STATE OF VERMONT  
PUBLIC SERVICE BOARD

Docket No. 7032

SURREBUTTAL TESTIMONY OF  
GEORGE E. SMITH  
ON BEHALF OF THE  
VERMONT DEPARTMENT OF PUBLIC SERVICE

June 27, 2005

Docket No. 7032  
 George E. Smith, Witness  
 Exhibit DPS-GES-12  
 Page 1 of 1

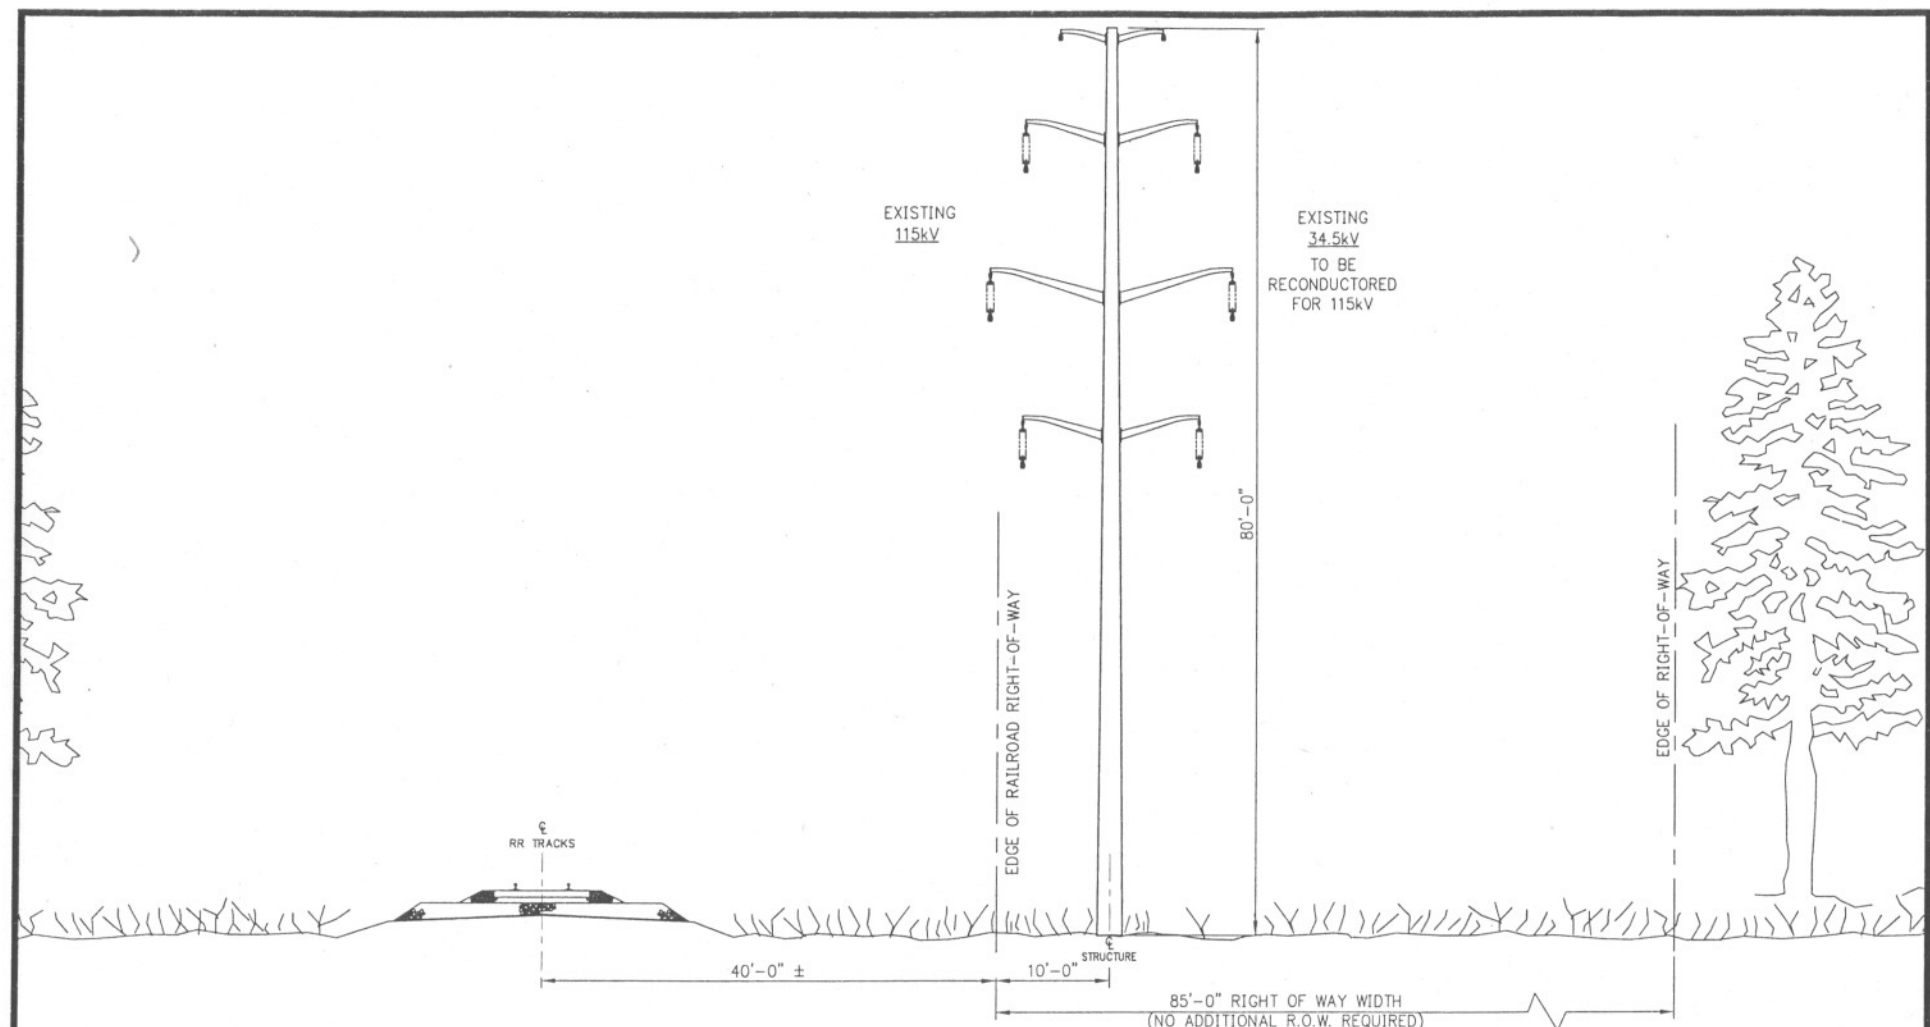
8 A. Yes. A single pole, double circuit configuration using davit arms would permit  
9 VELCO to perform the necessary maintenance with either or both circuits energized. This  
10 structure type is presently used by VELCO on its Williston to Queen City line where a  
11 VELCO 115 kV line is co-located with a Green Mountain Power Corporation 34.5 kV  
12 line. (See VELCO's Response 11 to the Department's Eleventh Set of Information  
13 Requests which is attached to this testimony as Exhibit DPS-GES-11.) A drawing  
14 illustrating this type of structure is provided as Exhibit DPS-GES-12.<sup>2</sup>

<sup>2</sup>The drawing attached as Exhibit DPS-GES-12 is intended only as an illustration of a single pole, double circuit davit arm structure type. As discussed below, a single shield wire rather than the double shield wire shown on this drawing would provide adequate lightning protection. Also, the pole can be constructed of wood, rather than steel, and be directly embedded into the ground.

20 A. The use of double circuits on a single pole requires that three of the phase  
21 conductors, instead of two, be placed on one side of the structure. Using the spacing  
22 scaled from the structures used for the Queen City line (refer to Exhibit DPS-GES-12),  
23 this would add approximately 13 ft to the height of the structures. (Note that VELCO uses  
24 a vertical spacing of 15 ft, rather than 13 ft, for their proposed single pole, single circuit  
25 115 kV structures.)
